UNITED STATES PATENT AND TRADEMARK OFFICE

10/796,359

Office Action Summary	Application No. 10/796,359	Applicant(s) HAWKINS ET AL.	
	Examiner Anu Ramana	Art Unit 3733

DETAILED ACTION

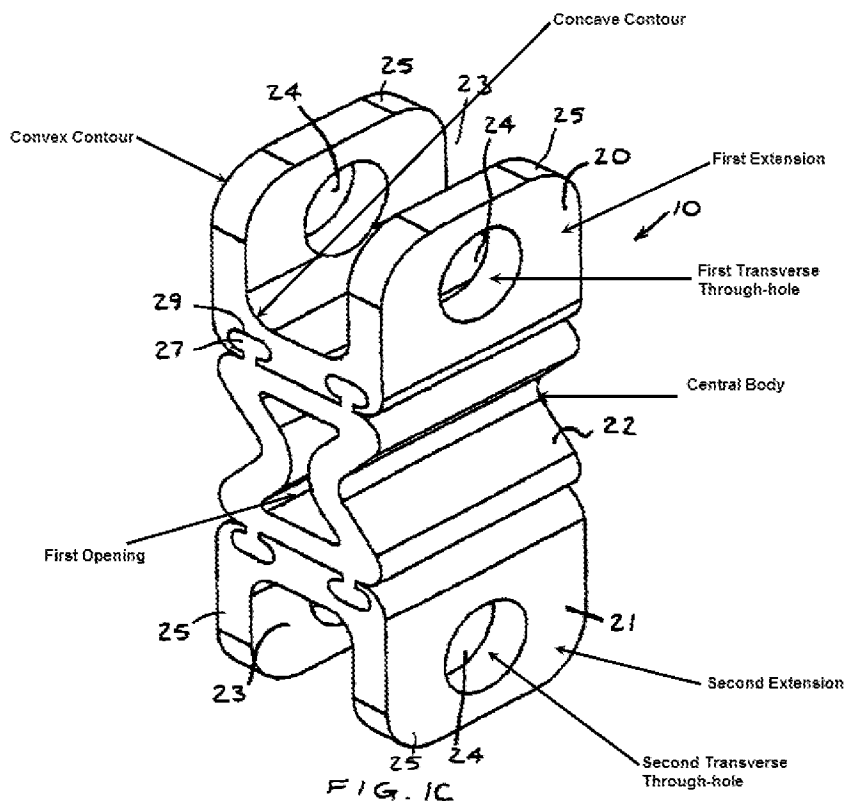
Claims 28-30, 44, 46-48 and 58 are rejected under 35 U.S.C. 102(e) as being anticipated by Amin et al. (US 7,011,685).

Arnin et al. disclose an interspinous implant including a central elastomeric body 22, a first extension 20, a second extension 21, and a rivet passing through a hole 24 in the first extension and thus having a first portion integral with the extension and a rivet passing through a hole 24 in the second extension (Fig. 1C, col. 3, lines 42-67 and col. 4, lines 1-36). Arnin et al. disclose the extensions to be made of titanium. It is noted that a rivet inherently has a male part or pin and a female part or pin. See marked up Fig. 1C from Arnin et al. below.

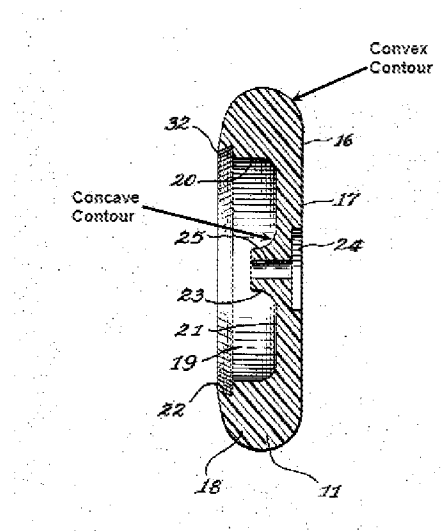
Claims 28-33, 35-36 and 46-48 are rejected under 35 U.S.C. 103(a) as being unpatentable over Duncan, Jr. (US 3,805,443) in view of Hoult (US 1,985,032).

Duncan, Jr. discloses all elements of the claimed invention except for a rivet having a first connecting pin having a male end and a second connecting pin having a female end. See previous discussion of Duncan, Jr.

It would have been obvious to one of ordinary skill in the art to substitute a two part rivet having a male end and a female end as, for example, taught by the Hoult reference for the rivet of the Duncan, Jr. device wherein so doing would amount to a simple substitution of one known fastener for another known fastener for the predictable result of fastening.

Duncan, Jr. discloses first and second extensions, each extension having an upper end, a lower end, an inner surface having a convex contour and an outer surface having a concave contour as illustrated in the marked up Figure 3 from Duncan, Jr. below.
